Allied Paper, Inc./Portage Creek/Kalamazoo River Superfund Site
Willow Boulevard/A-Site Landfill Operable Unit 2 Preliminary Design Report -
Addendum 1 – Responses to USEPA/MDNRE Draft Comments

As requested by USEPA, these responses are to be considered as Addendum 1 to the July 2010 Preliminary Design Report.

**BERM SECTION -
PRELIMINARY DESIGN**

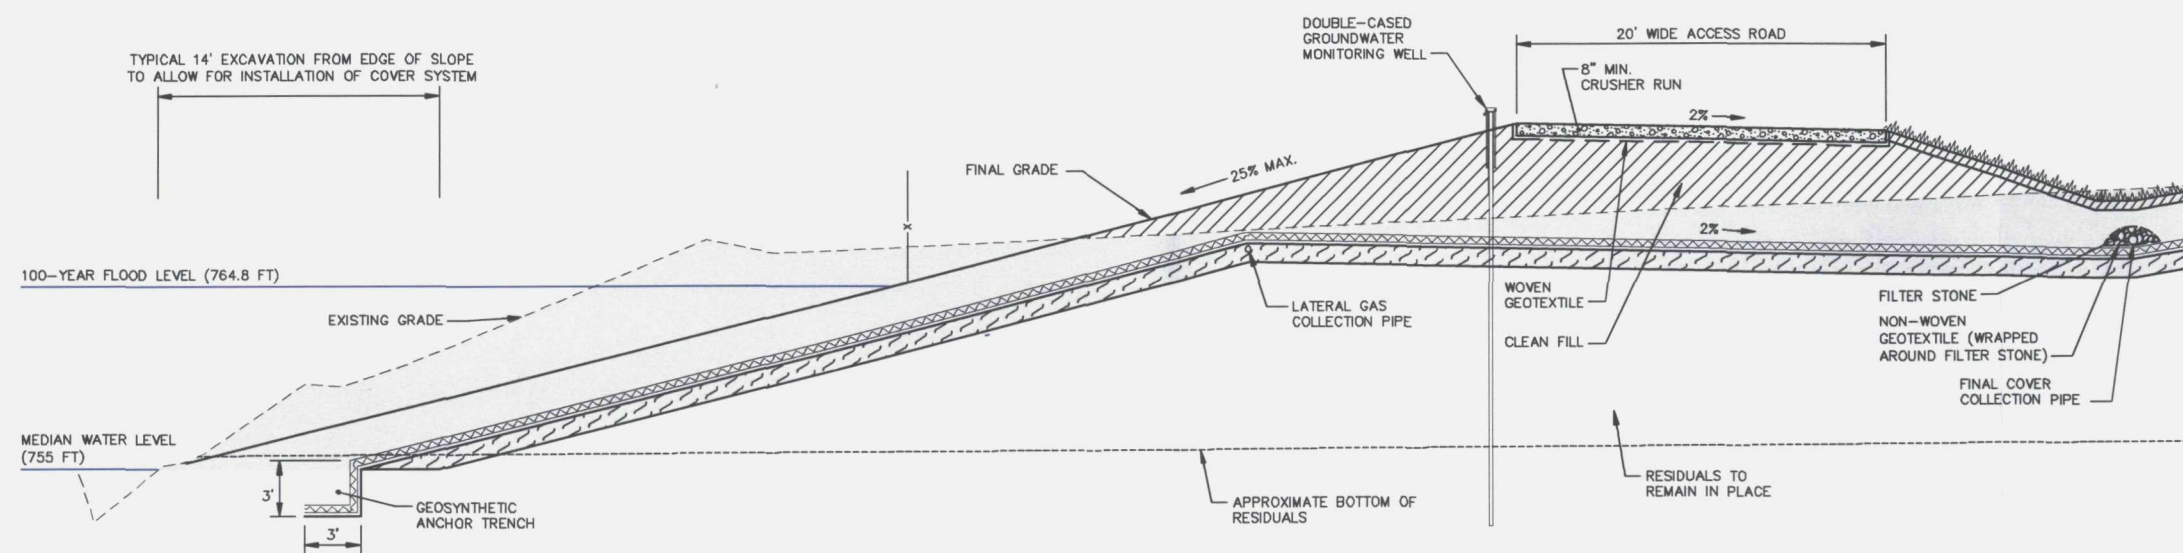
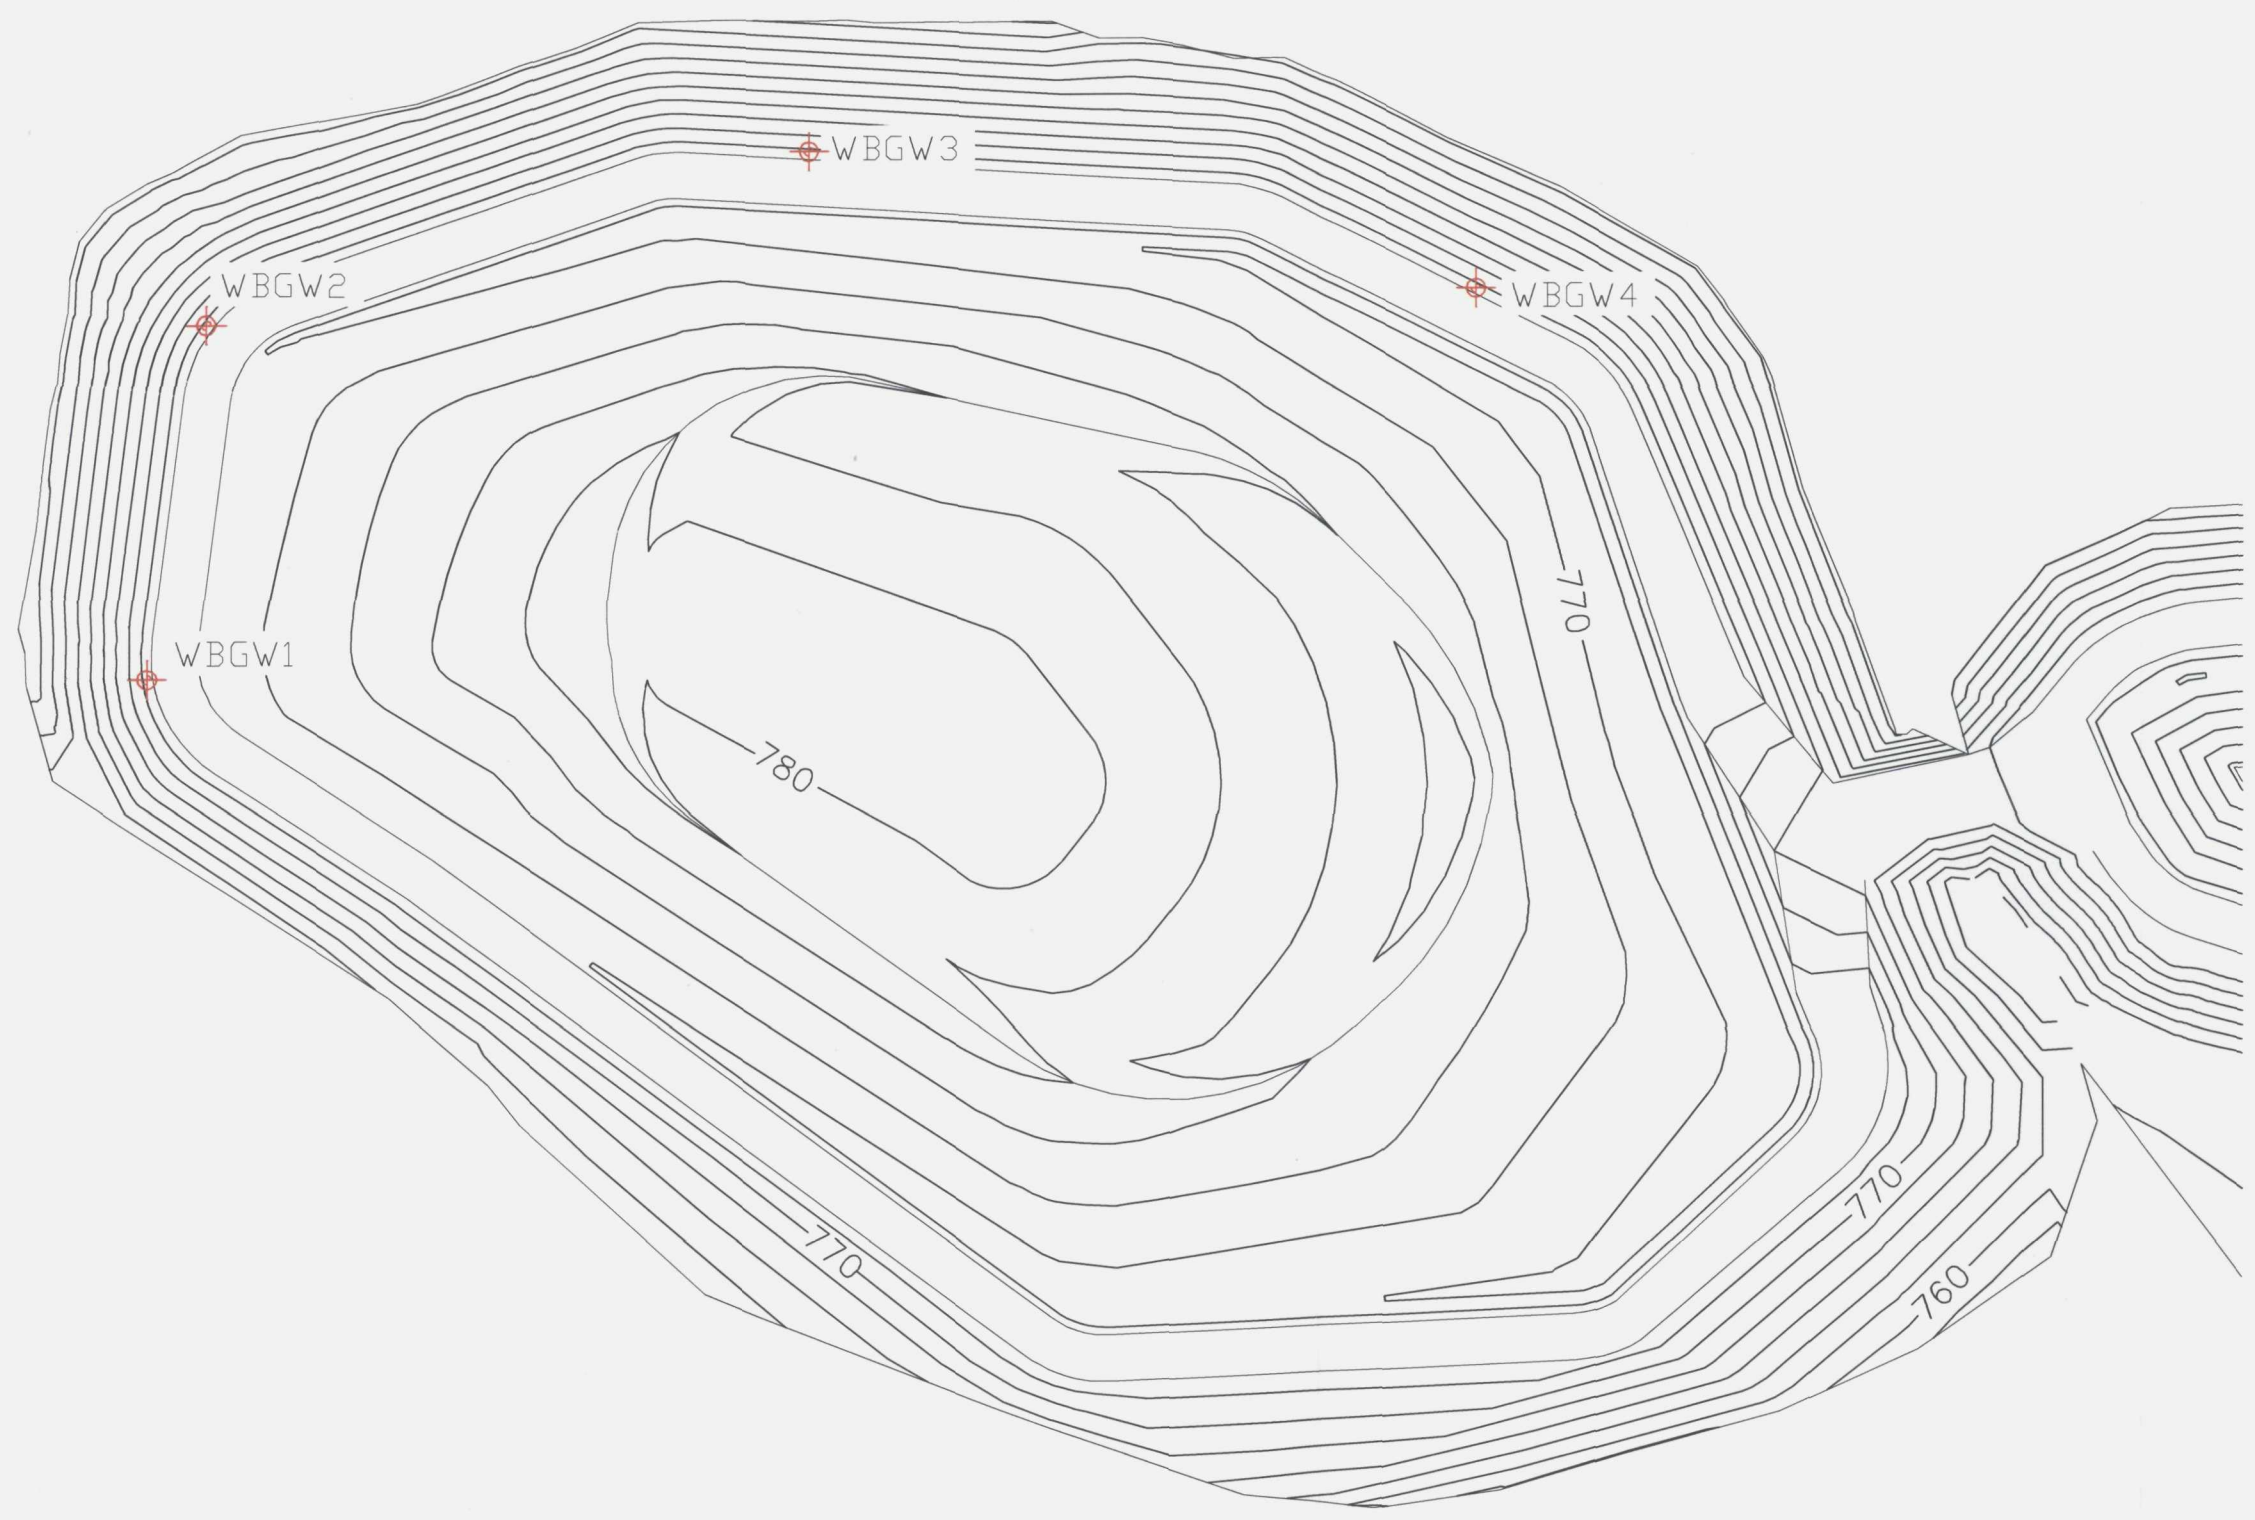
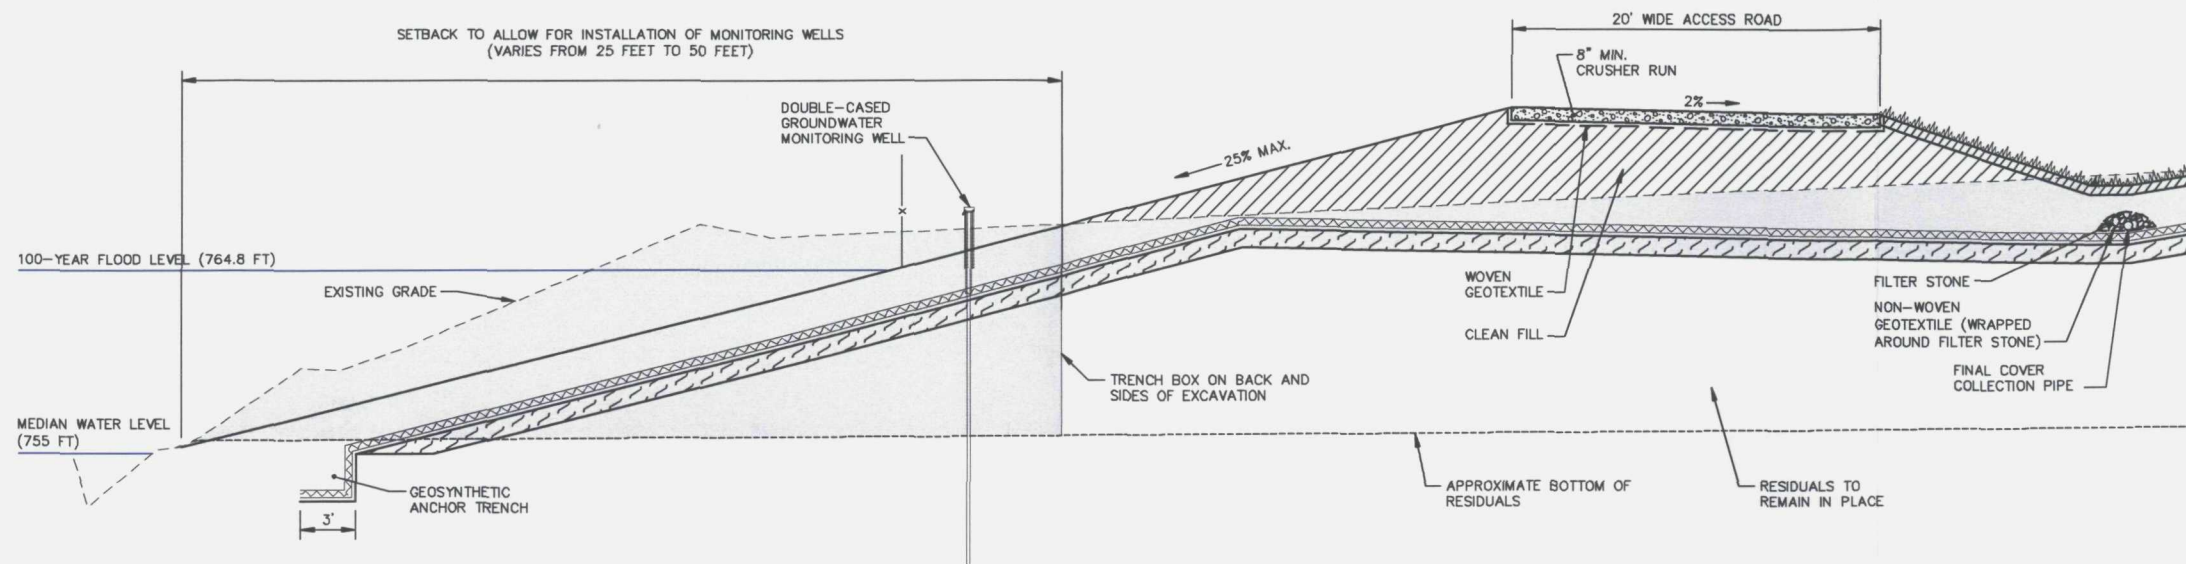
MDNRE Comment 2:

As identified in Section 1.1 Setback from Kalamazoo River at the Willow Boulevard Landfill of the SOW, "The excavation along the northern banks of the Willow Boulevard Landfill (along the Kalamazoo River) shall be of sufficient distance to create an adequate buffer zone, which ensures that, for the lifetime of the remedy, there is no direct contact between the contaminated residuals within the landfill and the Kalamazoo River. This

buffer will also be adequate to prevent PCBs from migrating (by surface water runoff or erosion) from the landfill into the Kalamazoo River. The excavated areas shall be backfilled with clean soil with sufficient organic content to support restoration planting materials and to create an ecologically friendly bank. Additionally, this buffer zone or setback shall be of sufficient size to allow for the installation of and access to groundwater monitoring wells." The preliminary design presented in the Preliminary Design Report and Construction Drawings do not meet this requirement of the SOW.

To prepare the northern and western slopes of Willow Boulevard for the proposed cover system, it will be necessary to excavate a minimum of 14 feet horizontally back from the edge of the Kalamazoo River (to get down below the base of existing paper-making residuals). In doing so, approximately 6,500 cy of material – including, to a practical extent, all residuals in this 14-foot buffer zone – will be removed from around the northern perimeter of the Willow Boulevard Landfill adjacent to the Kalamazoo River. This excavation will allow for the 3.5-foot thick cover system to be laid at a slope of 25% along the perimeter and the placement of approximately 6,000 cy of clean fill. The proposed final slopes of the northern and western perimeter of the Willow Boulevard Landfill will be able to accommodate equipment to install and access the necessary groundwater monitoring wells – the ability to successfully work on slopes of 25% was proven during the pre-design investigation boring installation along the northern berm. This is described in more detail below.

The buffer zone created by excavation to the required slopes will create a zone approximately 14 feet wide along the river that will be free of residuals. The cover system, which will be constructed over the regraded slope as well as the materials excavated and consolidated in the center of the landfill, will include 12 inches of sand, an impermeable membrane, geosynthetic drainage composite, 24 inches of soil and stone, and a 6-inch vegetative soil layer. The cover system will provide an impermeable barrier between the Willow Boulevard Landfill and the Kalamazoo River, and is designed to achieve the objectives of ensuring "no direct contact between the contaminated residuals in the landfill and the Kalamazoo River" and preventing erosion and run-off of PCB-containing paper-making residuals into the river, as described in the ROD and SOW.

During the teleconference with USEPA and MDNRE on August 25, 2010, USEPA expressed concern that the proposed approach for construction of the buffer zone was not consistent with the ROD, and that it would not allow installation of reliable monitoring wells. ARCADIS asserts that the construction approach as described above is consistent with the ROD. The ROD does not require a particular size, shape, or configuration of the buffer zone. Nor does it state that the monitoring wells cannot pass through residuals, rather the ROD only requires that the buffer be sufficient to allow installation of the wells and future access to the wells. The configuration as proposed in the Preliminary Design Report provides an adequate buffer zone to satisfy the requirements of the ROD. A cross section showing residuals excavation and proposed location of groundwater monitoring well is provided in Figure 2 and Figure 3 shows, in plan view, the monitoring well locations.
